Life Energy Motion

**Product Change Notification**  
**PCN-025\_2019\_1-OMTB1815601**  
**Replacing Red Phosphorus plastic material**  
**CAS-NP, CASR-NP and CKSR-NP series**  
**Date codes (see in red on page 3)**

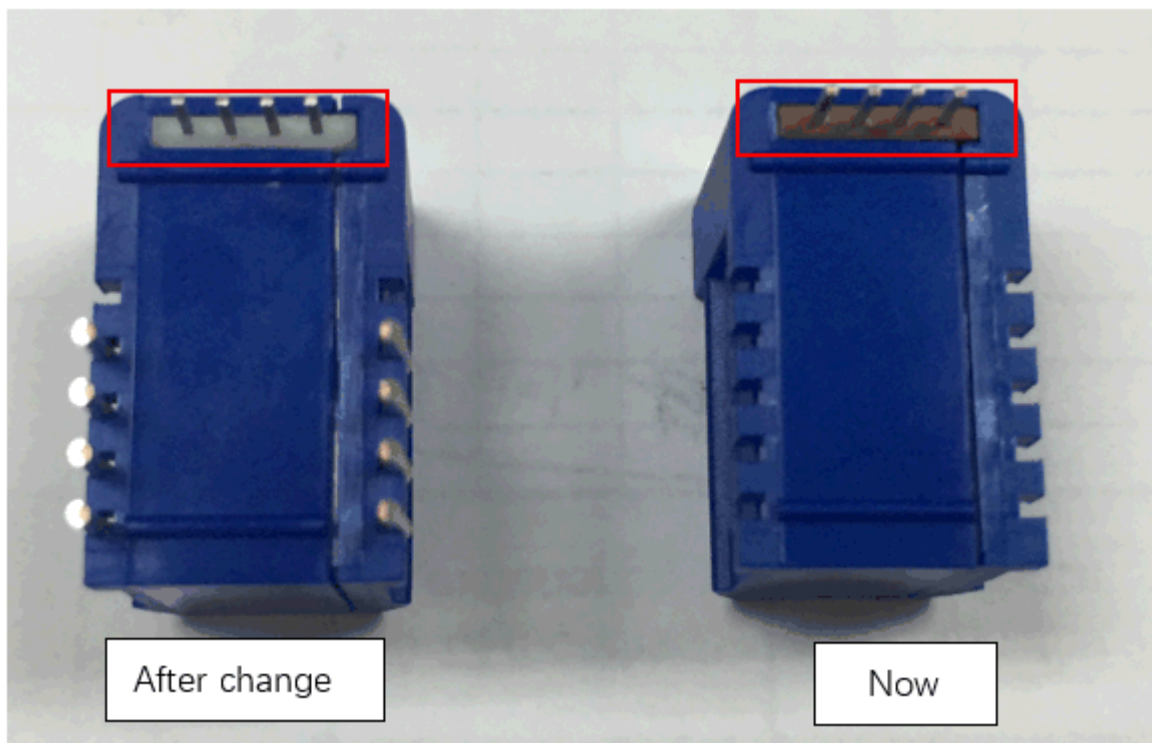
Replacing "Ultradid T KR 4365 G5" plastic material used for coil former and for the secondary connector (plastic support of the secondary pins) by another plastic material "Zytel HTNFR52G30NH NC010".

Previous plastic material was containing Red Phosphorus as material which is becoming banned from the market requirement.
